P802.1CQ–  
Proposed PALMA Description

Roger Marks (EthAirNet Associates)  
2019-11-04

- Updated PALMA flowcharts
- Proposed revision of subclause 5.2 (PALMA Summary) in Editor's Draft 0.3, primarily correcting editor's errors

# Client Listening State, Self-assigned Client

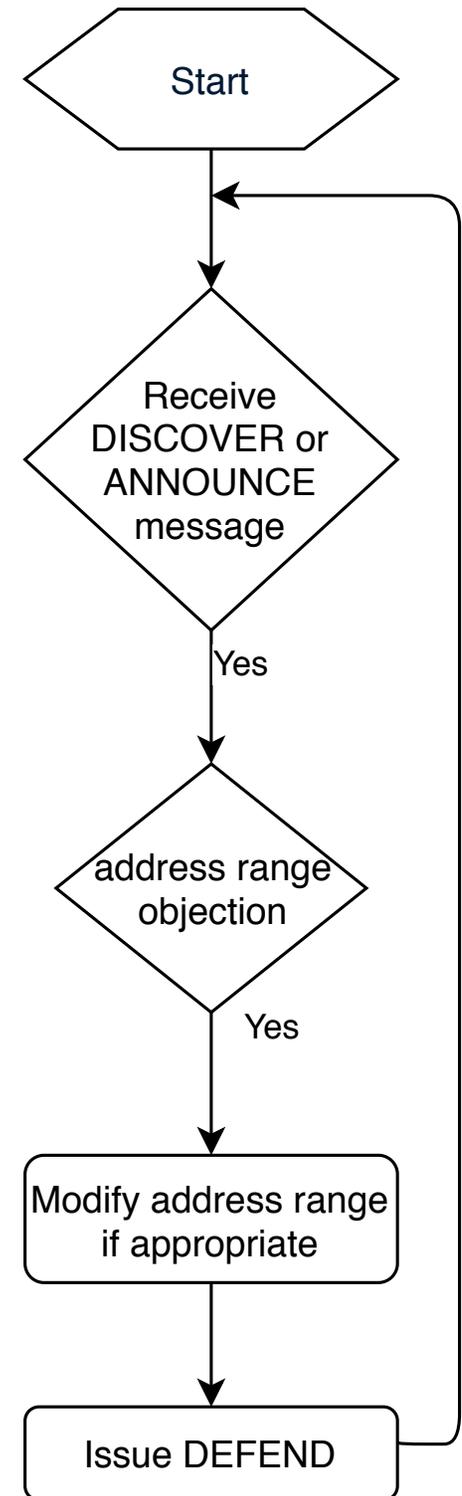
Note: Clients with server-assigned addresses need not receive or respond to the multicast DISCOVER or ANNOUNCE messages, since the server can respond to them.
